STAFF REPORT KETCHUM PLANNING AND ZONING COMMISSION REGULAR MEETING OF JANUARY 24, 2023

PROJECT: Appellation Hotel (formerly Harriman Hotel)

FILE NUMBER: P22-059 and P22-059A

SUBJECT: Design Review Comments Response

NOT FOR CONSTRUCTION

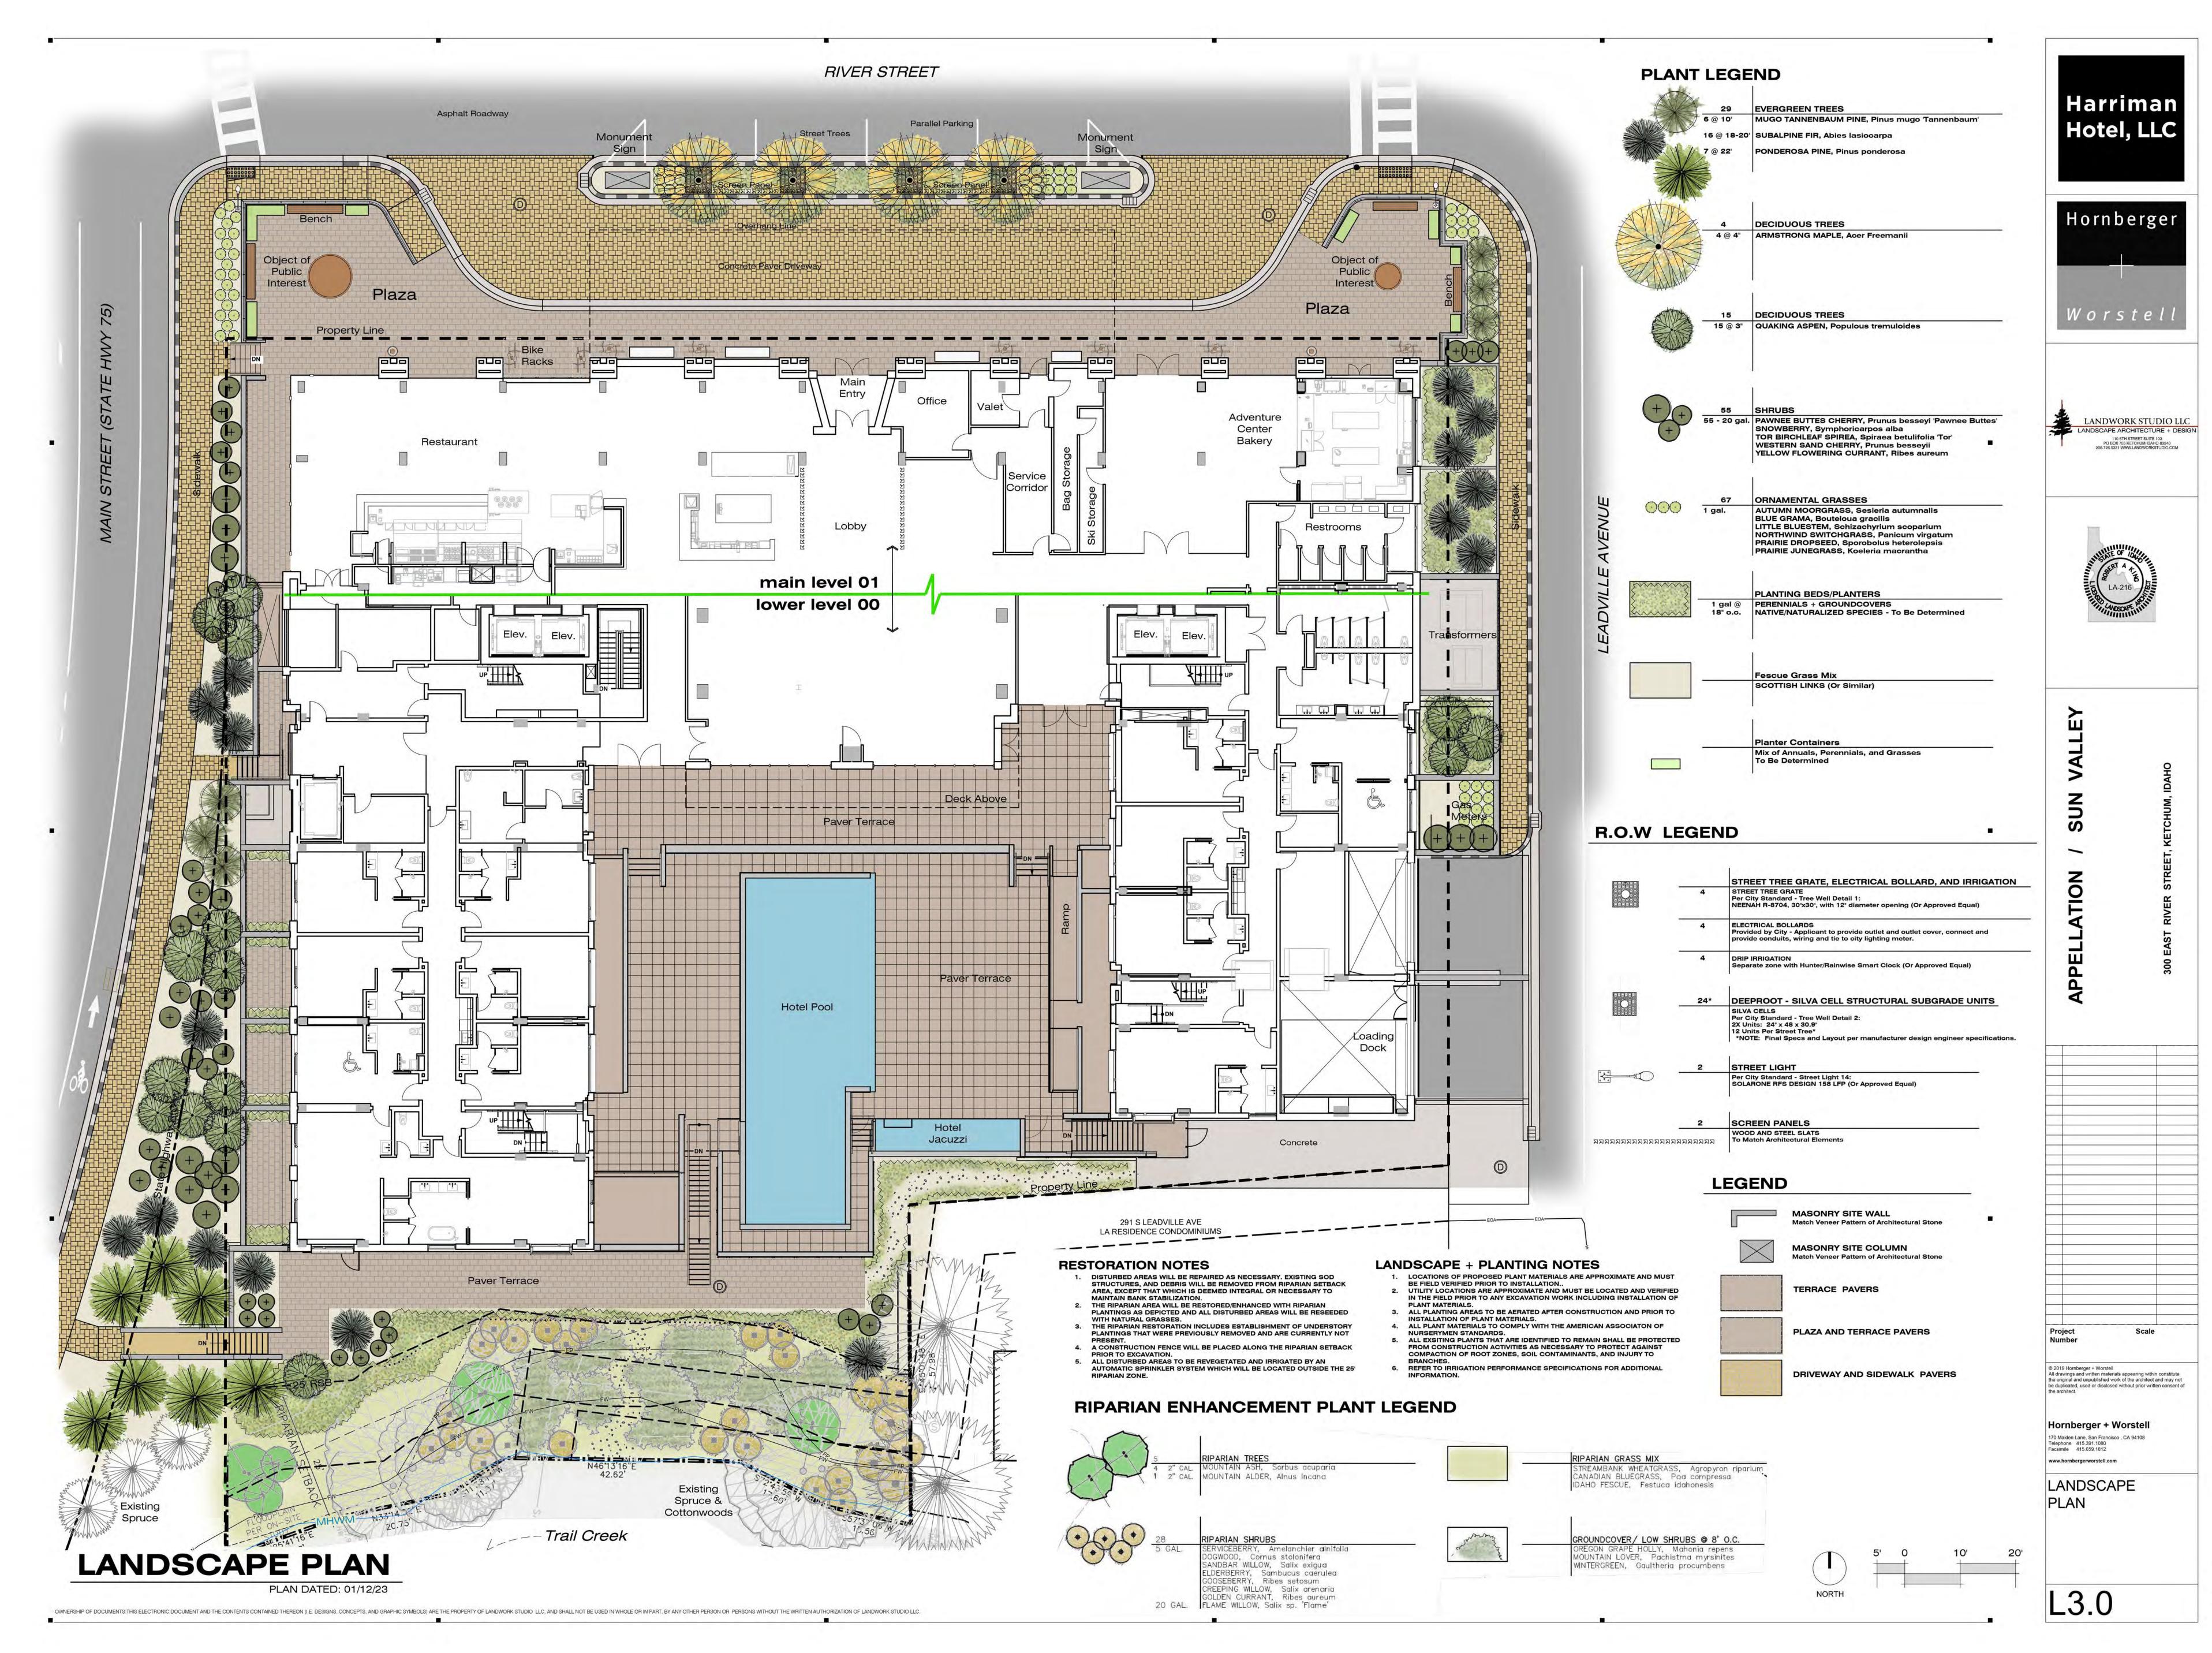
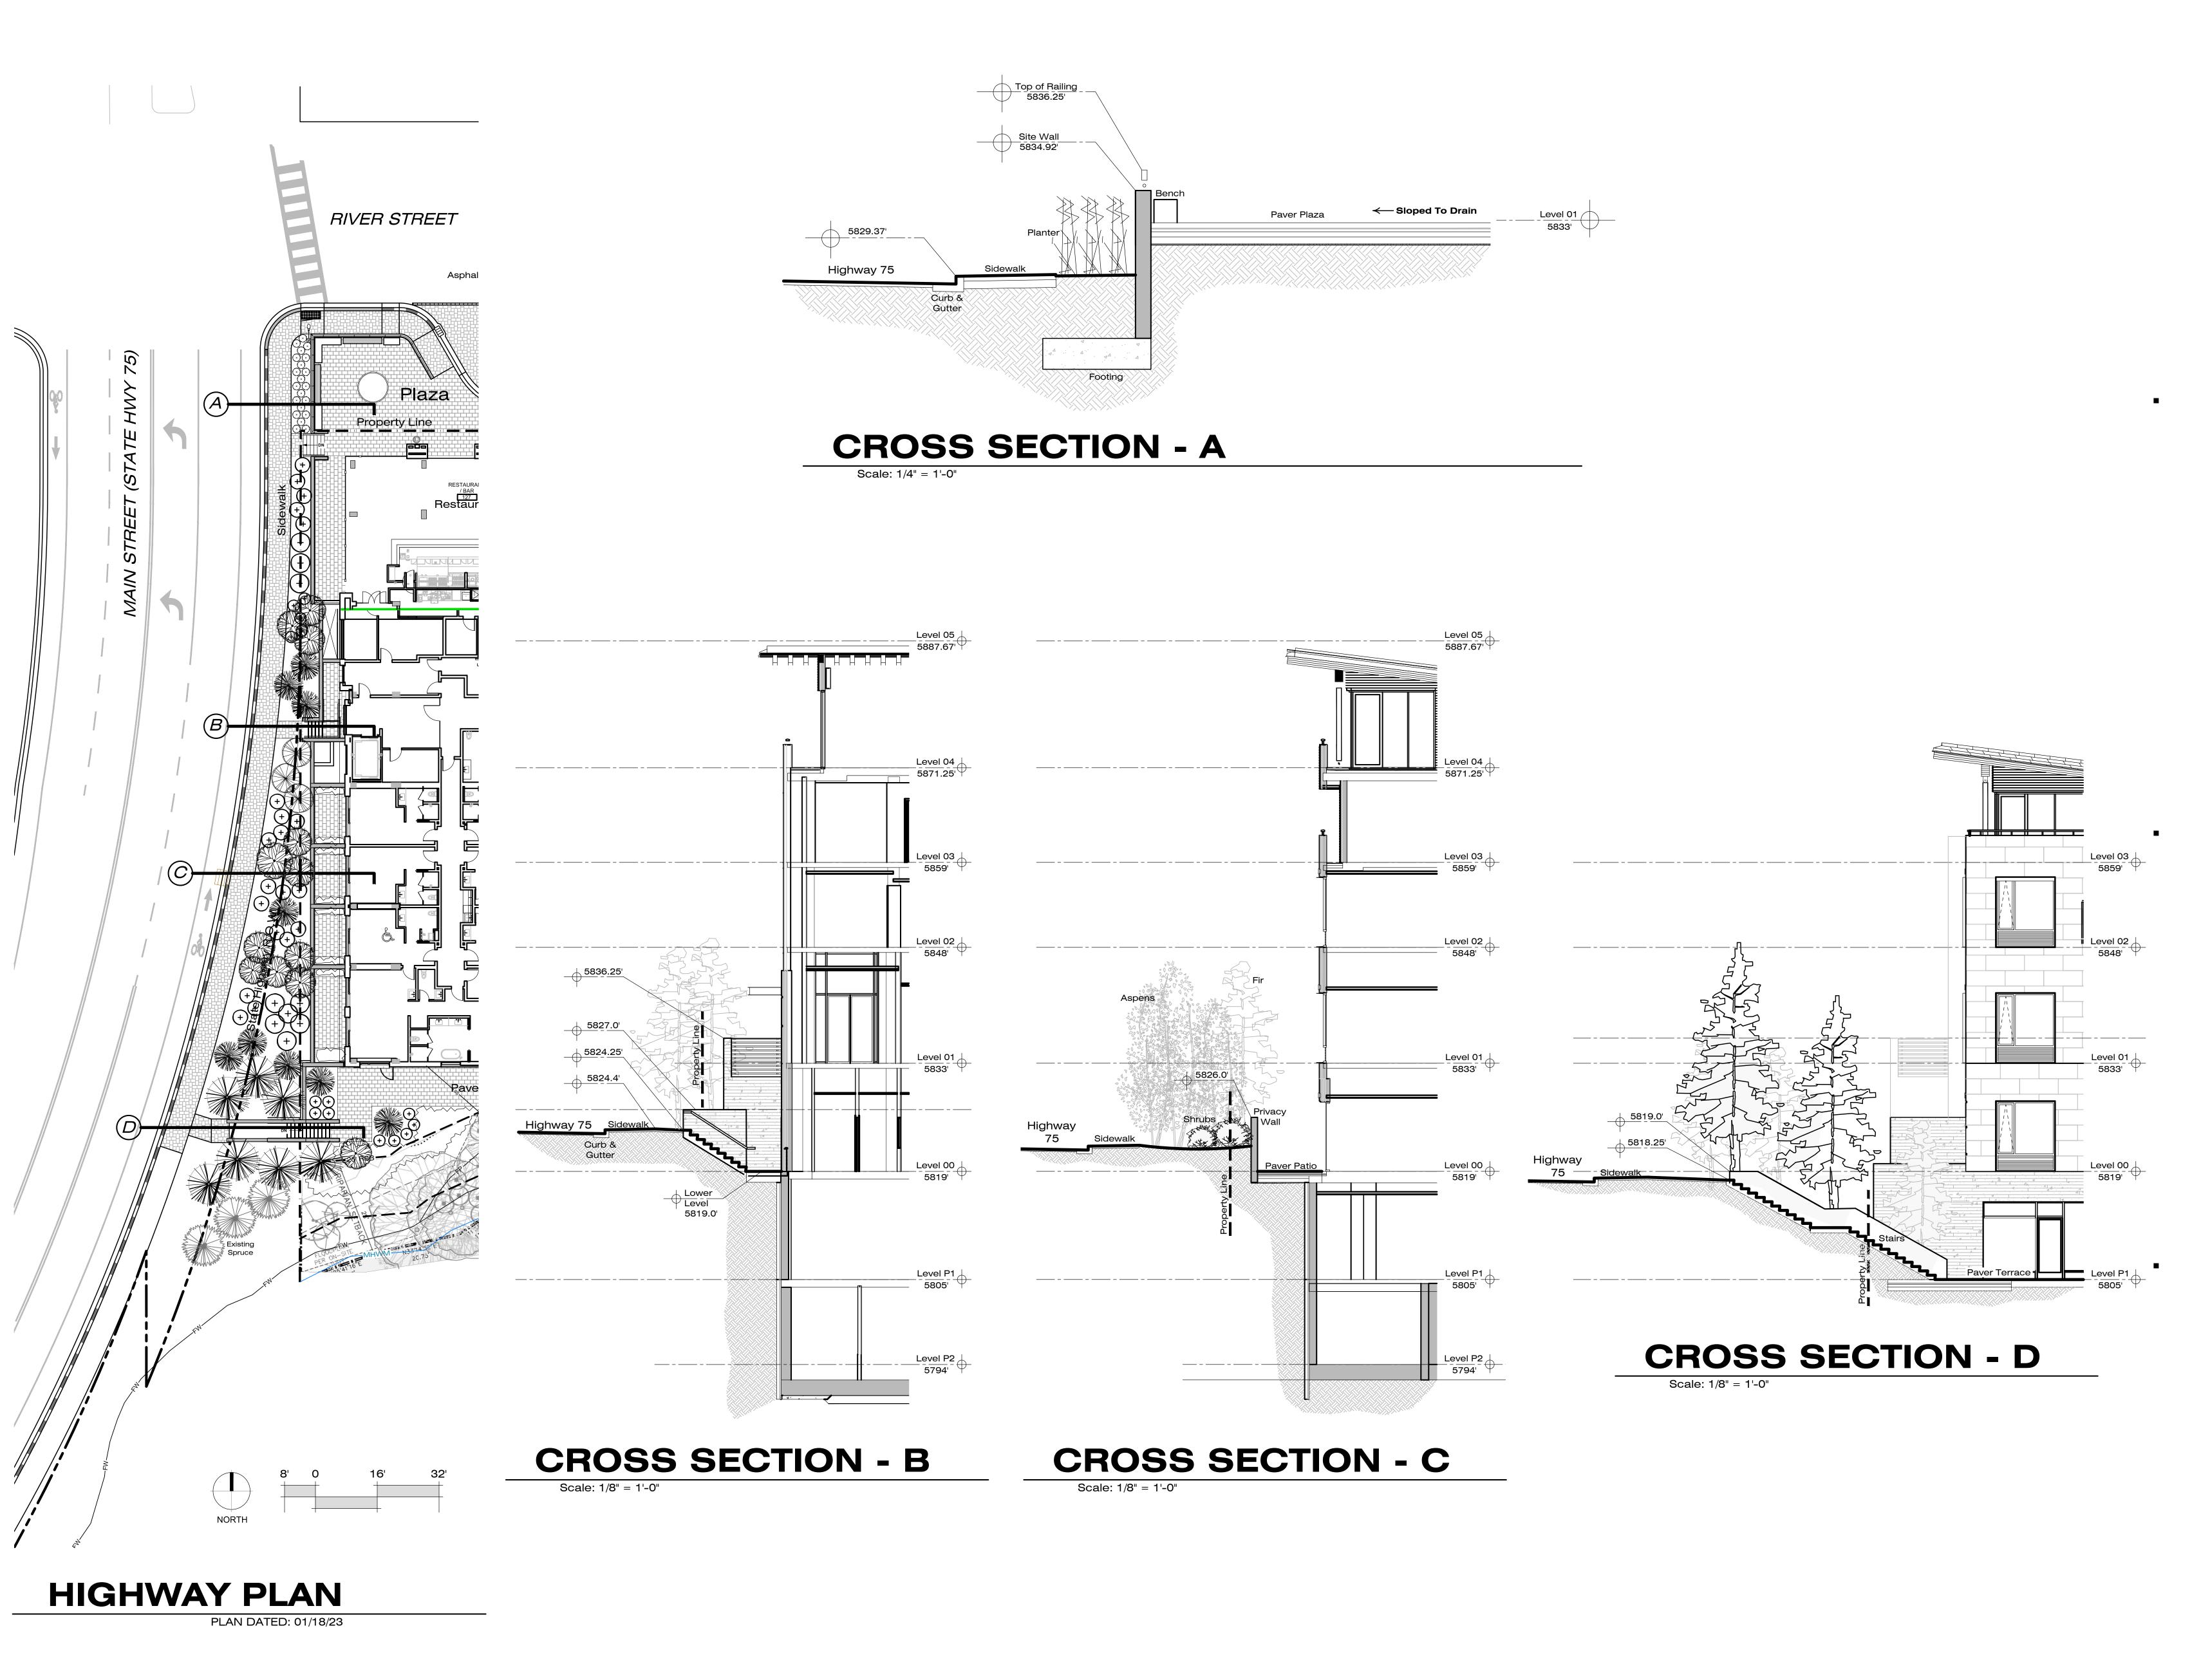
As shown on Sheet L3.0 of Attachment B, the current proposal has reworked the pool deck including a rotation of the pool 90 degrees and relocated the jacuzzi. The size of the jacuzzi has reduced and is in a similar area of the pool deck as the original approval. A landscape buffer has been reintroduced between the pool deck and the adjacent property to the east, although the buffer is much smaller than originally approved in 2008 as shown in Figure 4 above. As dimensioned on Sheet L1.1 of Attachment B, the current proposal sets the pool deck 6.5 feet from the property line to the

east allowing for some low-lying landscaping and a gravel walking path which provides egress to Leadville Ave. Staff believes this configuration is an improvement from the initial proposal in December and is supportive of the change. Staff does recommend consideration of creeping vines or other wall vegetation along the walls facing the adjacent residential property to provide relief and screening of the hard surface. Design Review Criteria #26 states "Substantial landscaping is to be provided, which is in scale with the development and which provides relief from and screening of hard surfaces. Total building surface area and street frontage will be considered when determining whether substantial landscape is being provided. (Landscape shall be defined as trees, shrubs, planters, hanging plants, ground cover, and other living vegetation)".

- Site plan updated to show revised Pool and Pool Deck Plan; opens L3.0 up riparian buffer zone.
- Landscape Plan updated to show more developed landscaping in buffer area and Trail Creek access feature.
